STAFF REPORT

August 11, 2021

Re: <u>Sunset Ridge Gating — Amended Site Plan Request</u>

Application No.: SPR-073-2021

EXHIBIT F DETAILED GATE PLANS

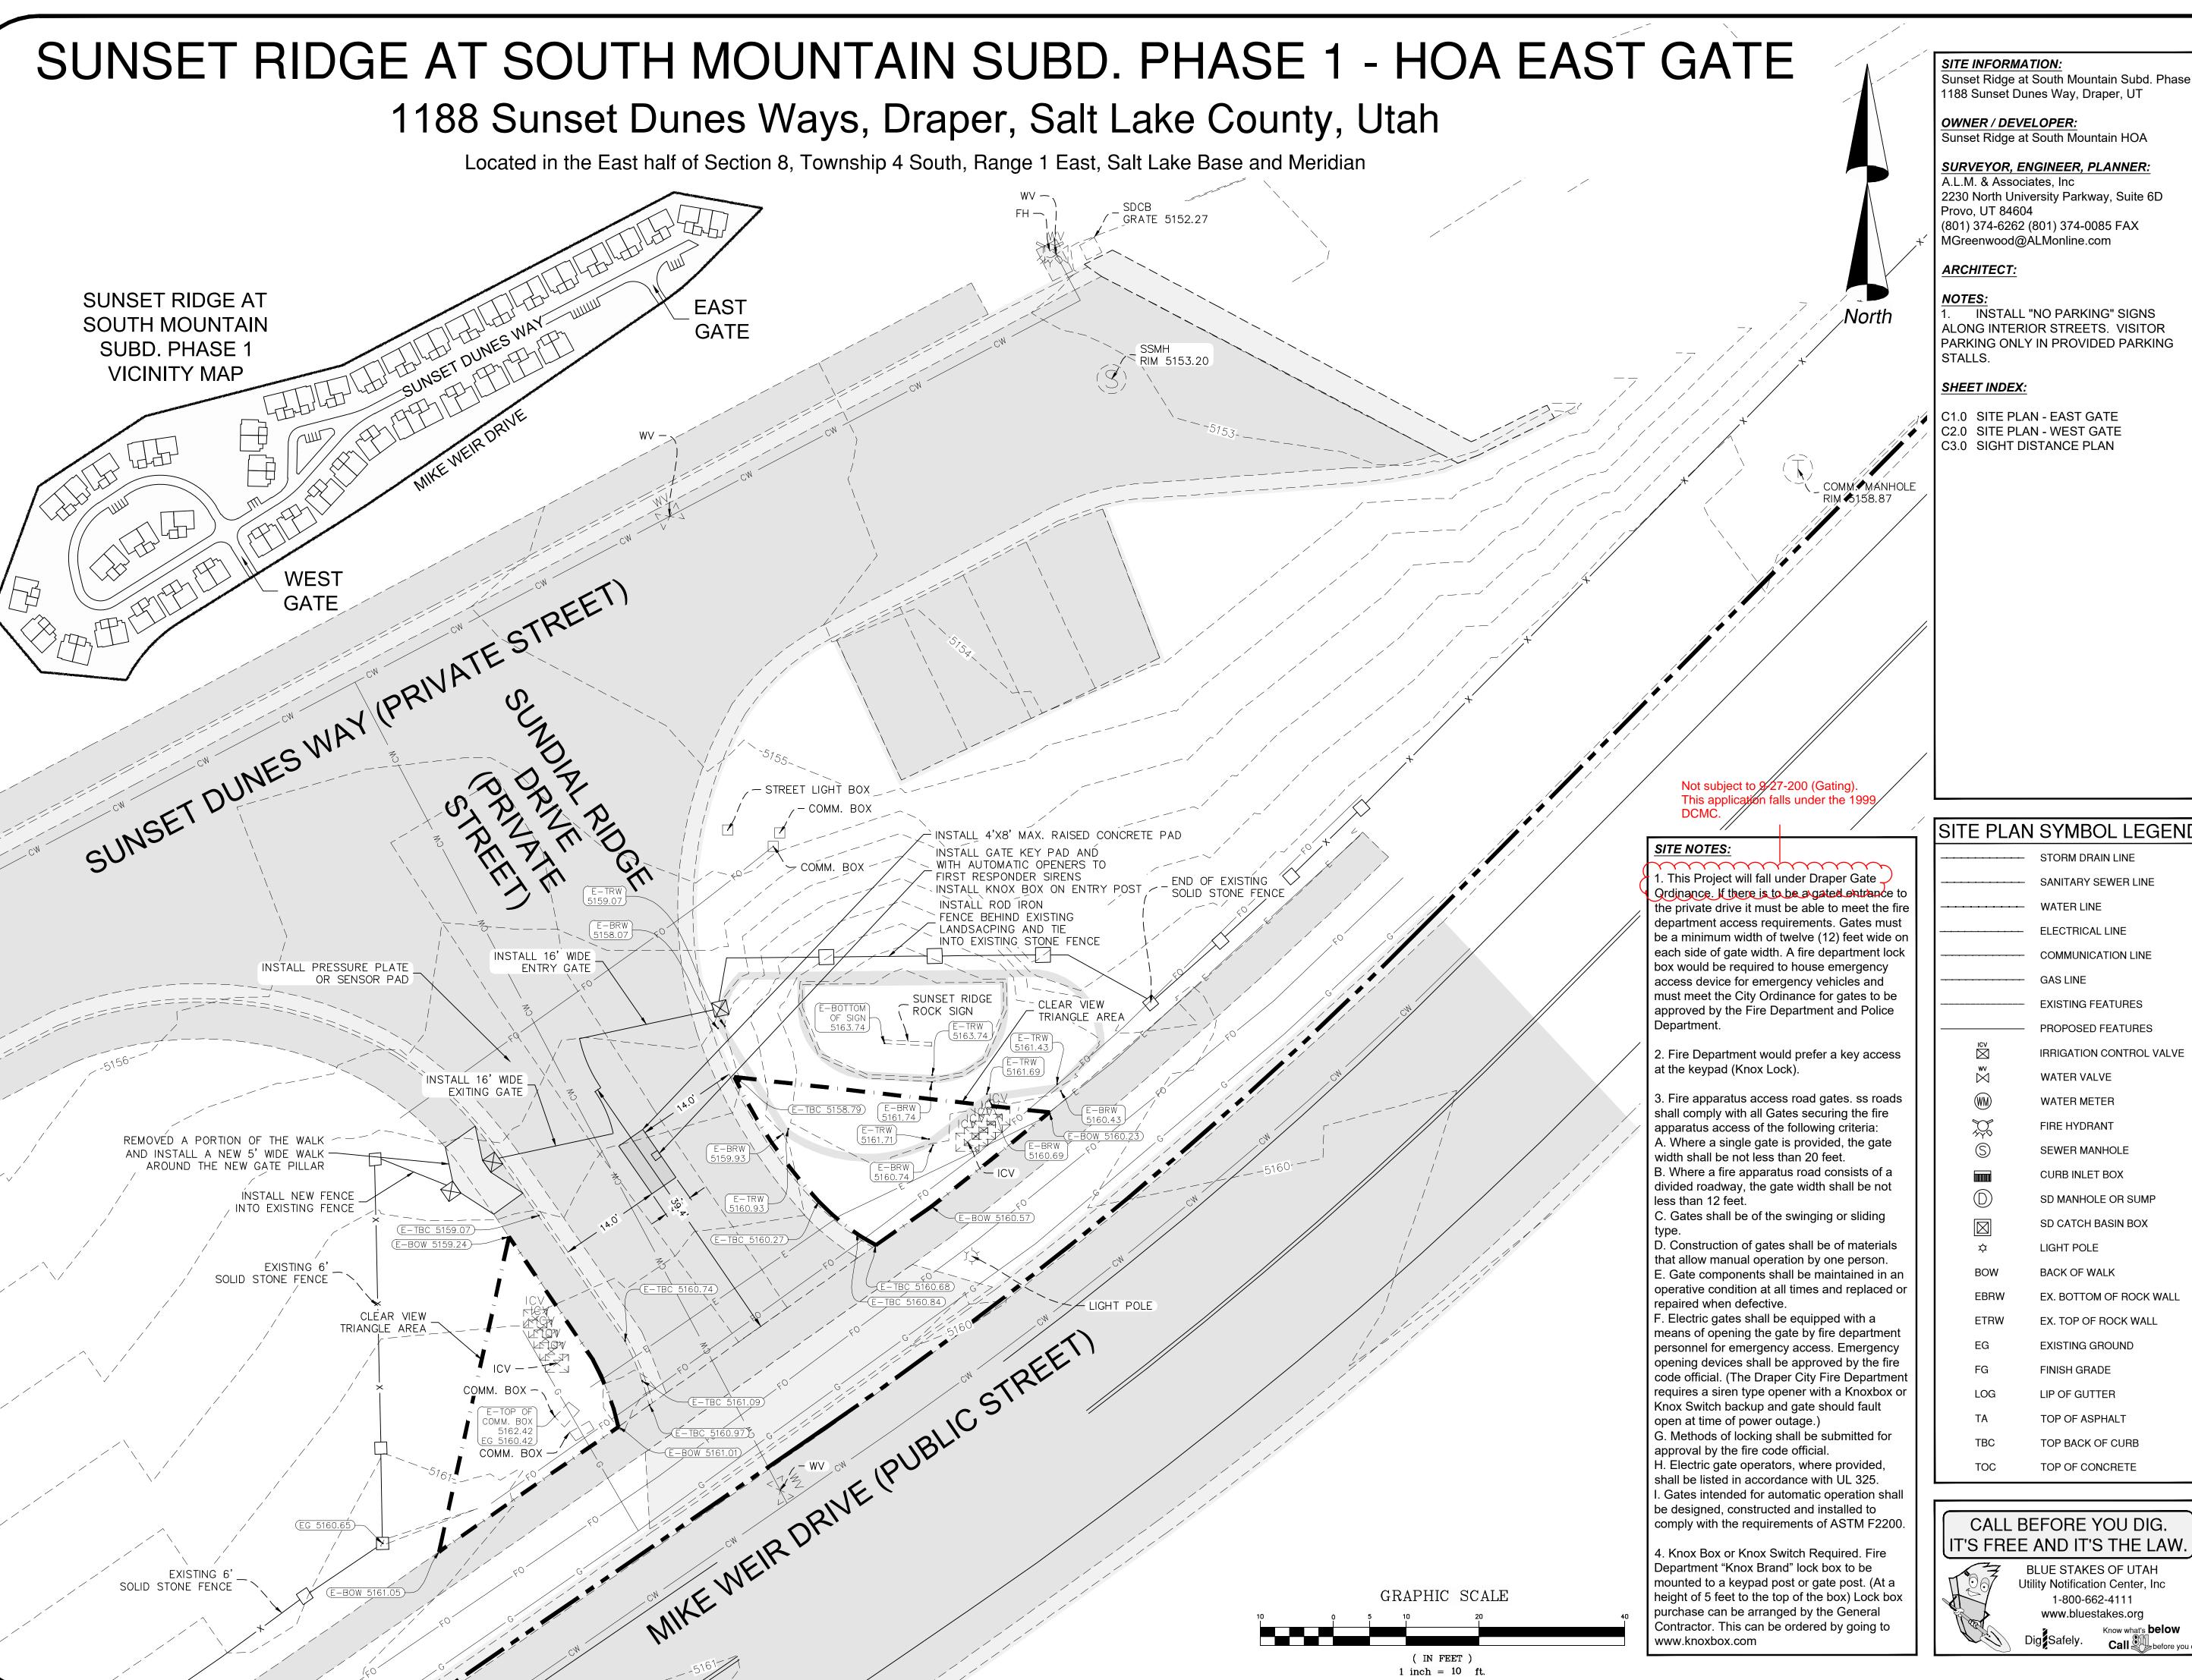
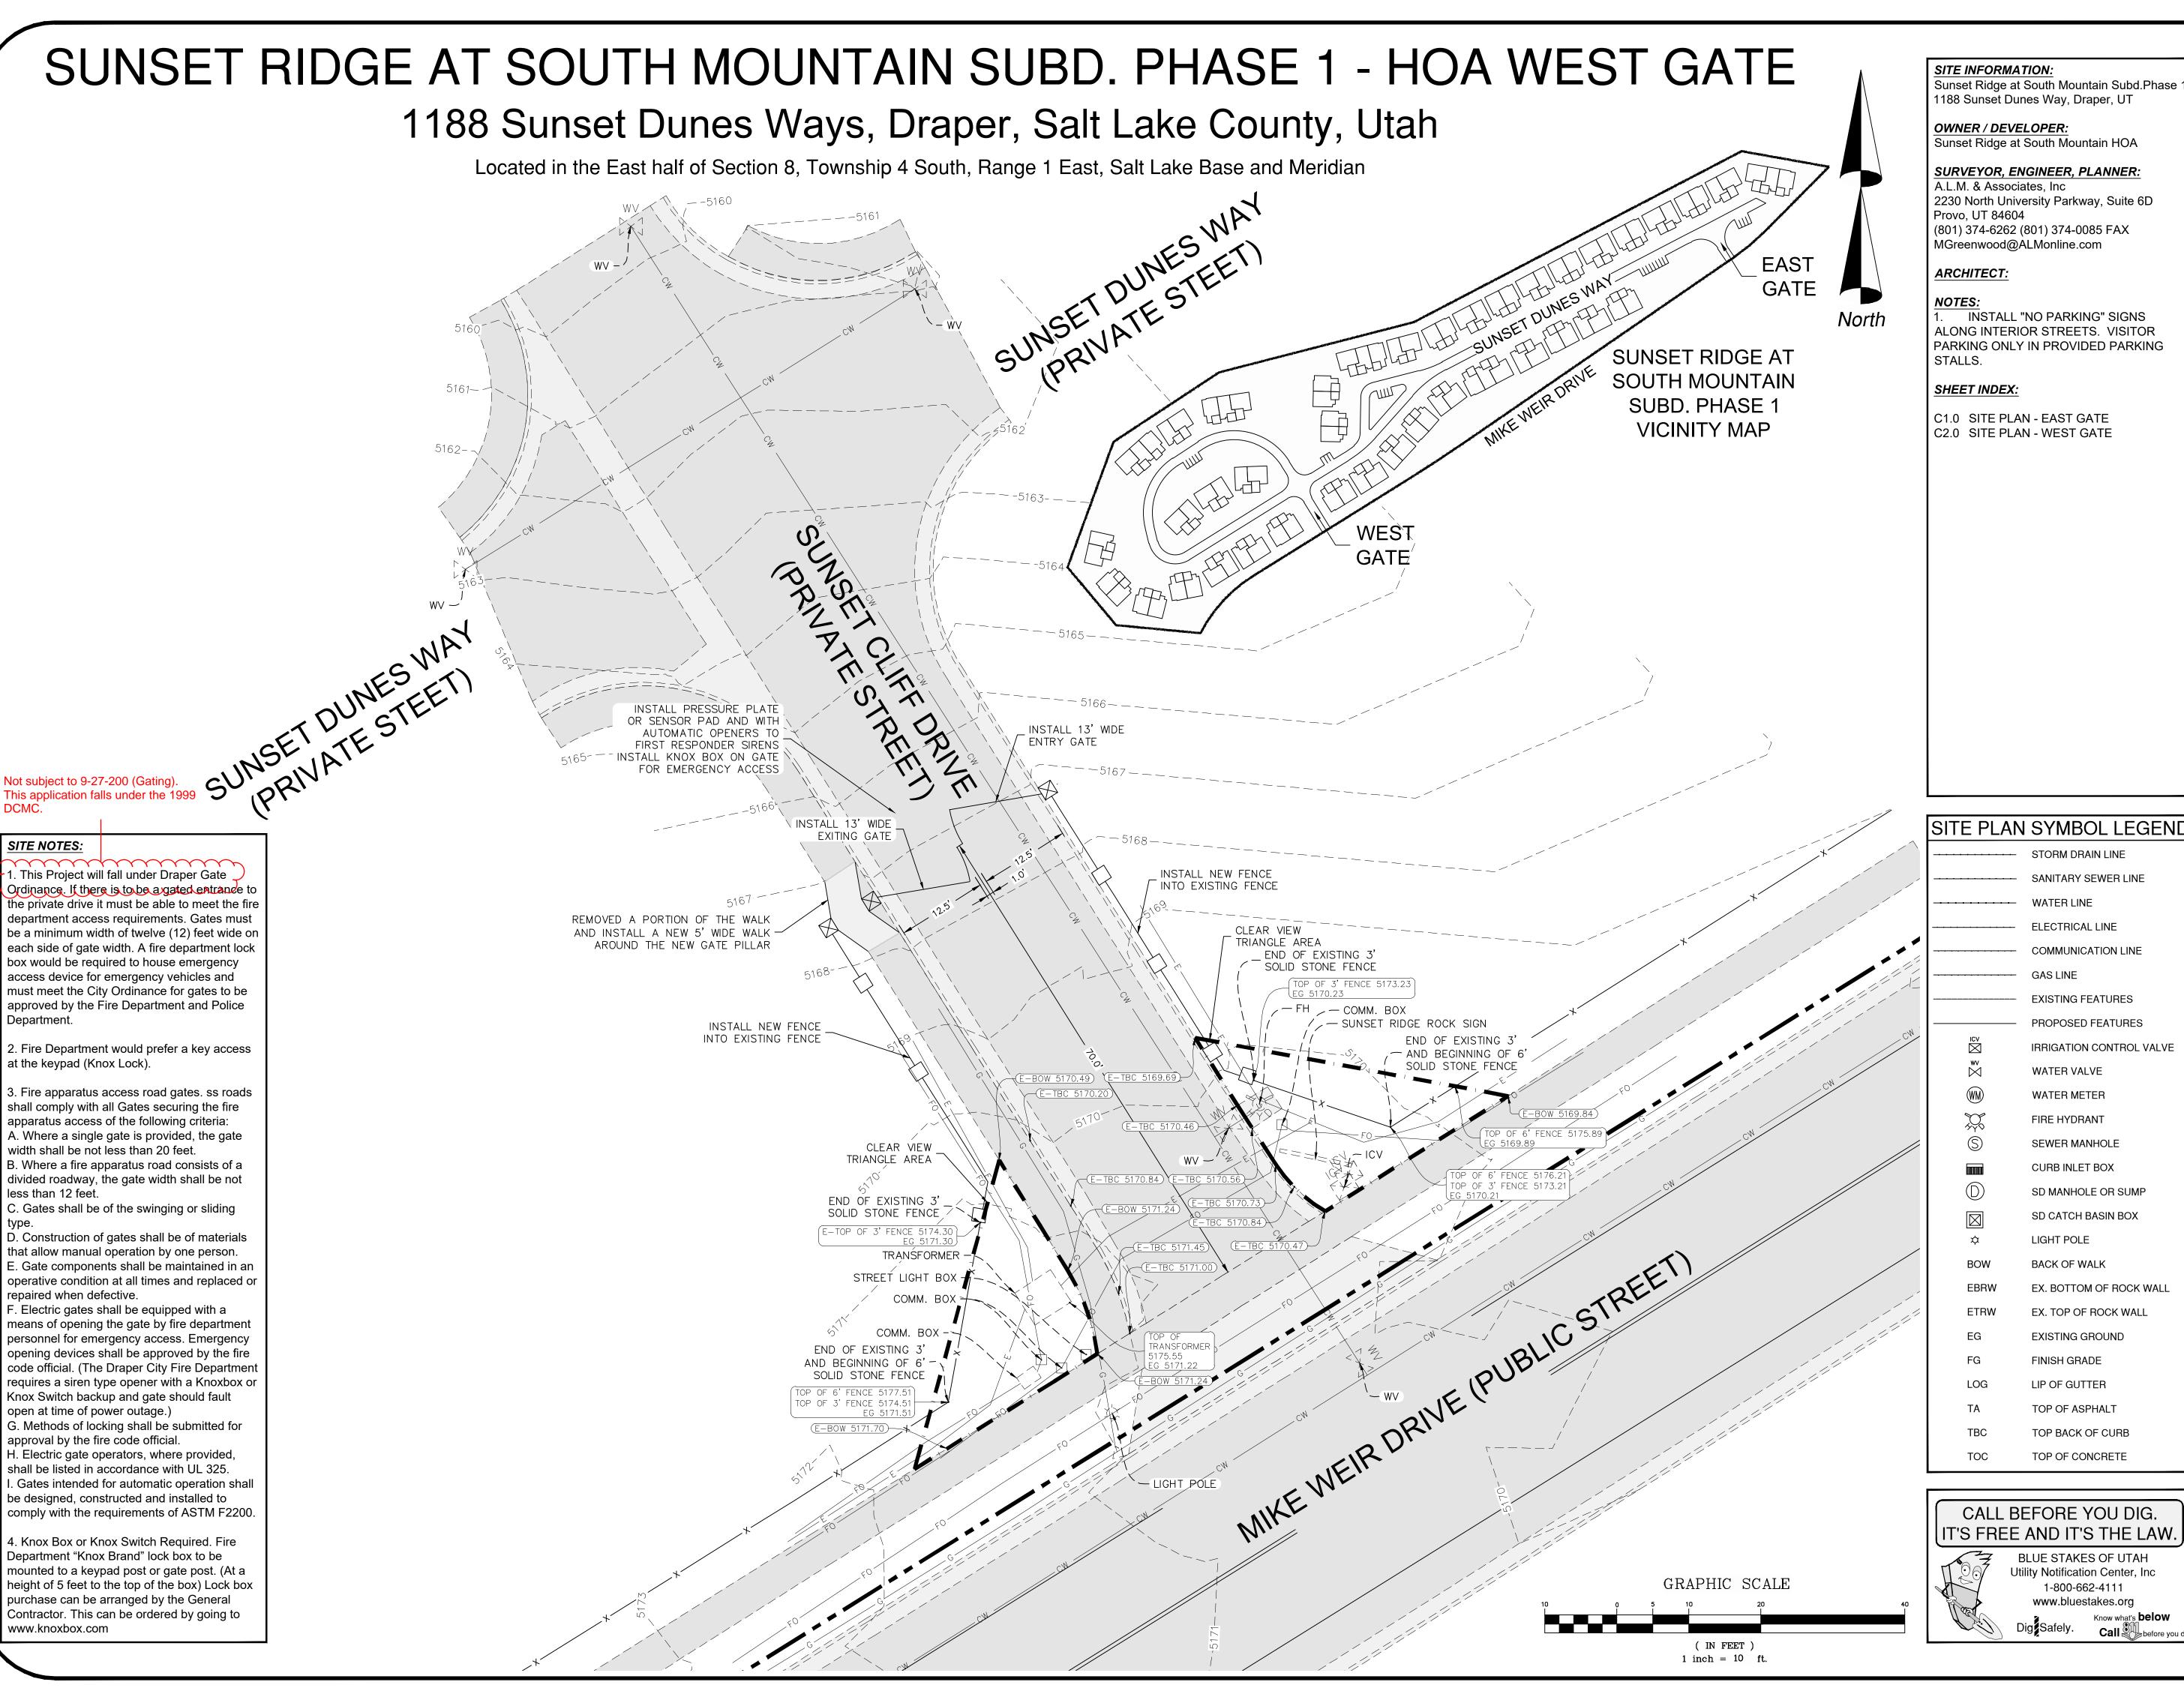
- 1. All proposed fencing and posts for fencings shall be placed outside of the sight triangle. Please adjust plans accordingly.
- 2. Landscaping within the clear view triangle and site triangle are required to meet the maximum height standards and may need to be modified from existing conditions to meet requirement. Existing trees may require trimming to remove lower branches and ensure visibility is maintained.

- 2. This Project does not fall under the Draper Gate Ordinance as it falls under the 1999 DCMC. If there is to be a gated entrance to the private drive it should be able to meet the fire department access requirements. Gates should be a minimum width of 12 feet wide on each side of gate width. A fire department lock box would be required to house emergency access device for emergency vehicles and must meet the City Ordinance for gates to be approved by the Fire Department and Police Department.

- 3. D103.5 Fire apparatus access road gates. Gates securing the fire apparatus access roads shall comply with all of the following criteria:
 - A. Where a single gate is provided, the gate width shall be not less than 20 feet (6096 mm).

- B. Where a fire apparatus road consists of a divided roadway, the gate width shall be not less than 12 feet (3658 mm).
 - C. Gates shall be of the swinging or sliding type.

- Electric gates shall be equipped with a means of opening the gate by fire department personnel for emergency access. Emergency opening devices shall be approved by the fire code official. The Draper City Fire Department requires a siren type opener with a Knoxbox or Knox Switch backup and gate should fault open at time of power outage.

- 4. Knox Box or Knox Switch Required. Fire Department "Knox Brand" lock box to be mounted to a keypad post or gate post, at a height of five feet to the top of the box. Lock box purchase can be arranged by the General Contractor. This can be ordered by going to www.knoxbox.com
